Access Compliance Report

Public Rights-of-Way

(Curb Ramps)

Intersection ID: N/A	Main Street: CRESSWIND BV	Cross Street: SHOFF CIR	Location: W
ADA ID: 7D156FA75DCE	Ramp Type: BlendTrans1	Initial Pass/Fail: Fail	Overall Compliance: No
Severity Score: 10			
Codes/Mitigation Info/Possible Solution		Field Measurements/Component Compliance

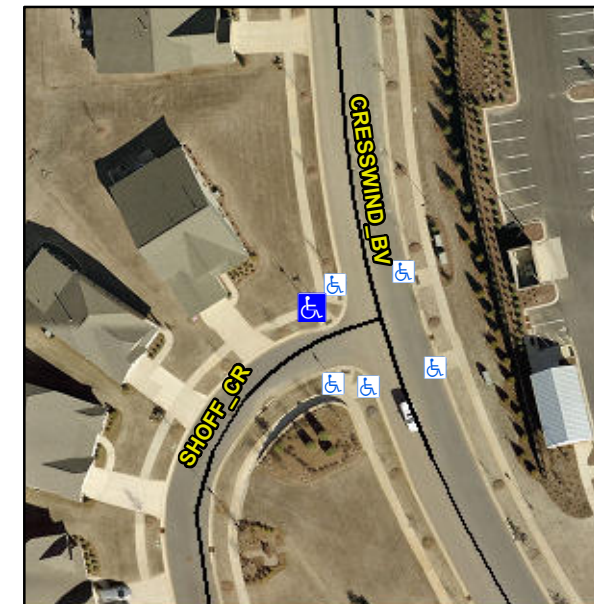
R304.5.1, R304.5.3

Compliance	Description	Data	Compliance	Description	Data
N/A	Ramp Length (in)	111.0	Yes	BlendTrans Slope (%)	0.6
No	Ramp Width (in)	47.0	No	BlendTrans XSlope (%)	4.0
N/A	Flare Type LT	N/A	N/A	Flare Type RT	N/A
N/A	Flare Slope LT (%)	N/A	N/A	Flare Slope RT (%)	N/A
N/A	Flare Traversable LT?	No	N/A	Flare Traversable RT?	No
N/A	Landing Length (in)	N/A	N/A	DWS Provided?	N/A
N/A	Landing Width (in)	N/A	N/A	DWS Contrast?	N/A
N/A	Landing Slope (%)	N/A	N/A	DWS Length (in)	N/A
N/A	Landing X Slope (%)	N/A	N/A	DWS Full Width?	N/A
N/A	Landing Curb? (Y/N)	N/A	N/A	DWS Offset (in)	N/A
N/A	Shared Landing?	N/A			
N/A	Gutter Ponding?	N/A	N/A	Gutter Slope (%)	N/A
N/A	Gutter Lip Ht (in)	0.5	N/A	Gutter X Slope (%)	N/A
N/A	Painted X Walk1?	No	N/A	Painted X Walk2?	N/A
	X Walk 1 Direction	To SE		X Walk 2 Direction	N/A
	X Walk 1 Width (in)	N/A		X Walk 2 Width (in)	N/A
	X Walk 1 Slope (%)	3.2		X Walk 2 Slope (%)	N/A
	X Walk 1 X Slope (%)	2.2		X Walk 2 X Slope (%)	N/A

Remove & Replace Curb Ramp With Two New Directional Ramps or Equivalent.
